NEW MEXICO OIL CONSERVATION DIVISION
 - Engineering Bureau -
 1220 South St. Francis Drive, Santa Fe, NM 87505

Apache
Marshall B #1, 2, 7, 9 & 10

ADMINISTRATIVE APPLICATION CHECKLIST

RE: Administrative approval for
Non-Standard Gas Spacing Unit
Tubb Oil & Gas (Pro Gas) Pool
and Simultaneous Dedication
Blinebry Oil & Gas (Pro Gas) Pool
Township 21 South, Range 37 East;
Section 27: SW¼ (Marshall B Lease)
Lea County, New Mexico

Tracts adjoining the SW/4 of Section 27

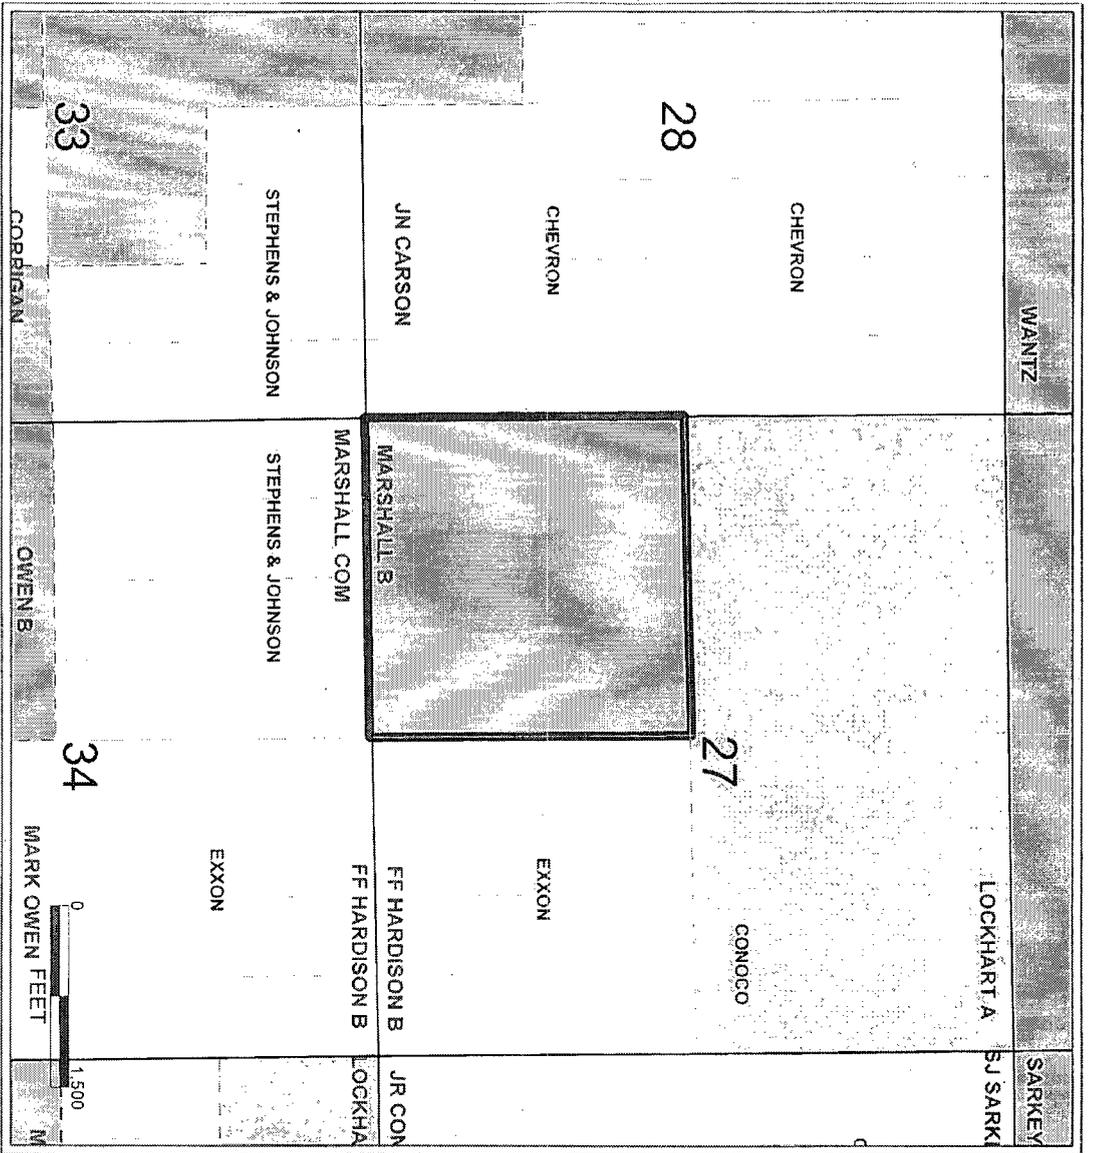
In order that I can be certain appropriate notices were given of this application, I would appreciate you furnishing us a plat depicting the units adjoining the SW/4 of Section 27, and indicating the operators or owners notified for each such unit.

In order that I can be certain appropriate notices were given of this application, I would appreciate you furnishing us a plat depicting the units adjoining the SW/4 of Section 27, and indicating the operators or owners notified for each such unit.

In order that I can be certain appropriate notices were given of this application, I would appreciate you furnishing us a plat depicting the units adjoining the SW/4 of Section 27, and indicating the operators or owners notified for each such unit.

Please see attached Offset Owner list and plat. I notified John H. Hendrix and J.R. Cone and probably didn't need to since those parties are not in the adjoining tracts. I have sent in other Applications for the Mark Owen Lease, Walter Lynch Lease and Lou Worthan Lease. You may not have these applications in hand yet, but I'm sure you are going to need this information for those Leases as well so I will work on getting you further information. I apologize for not providing this information with the applications. I have never done an application before so I greatly appreciate your patience and thank you for your help.
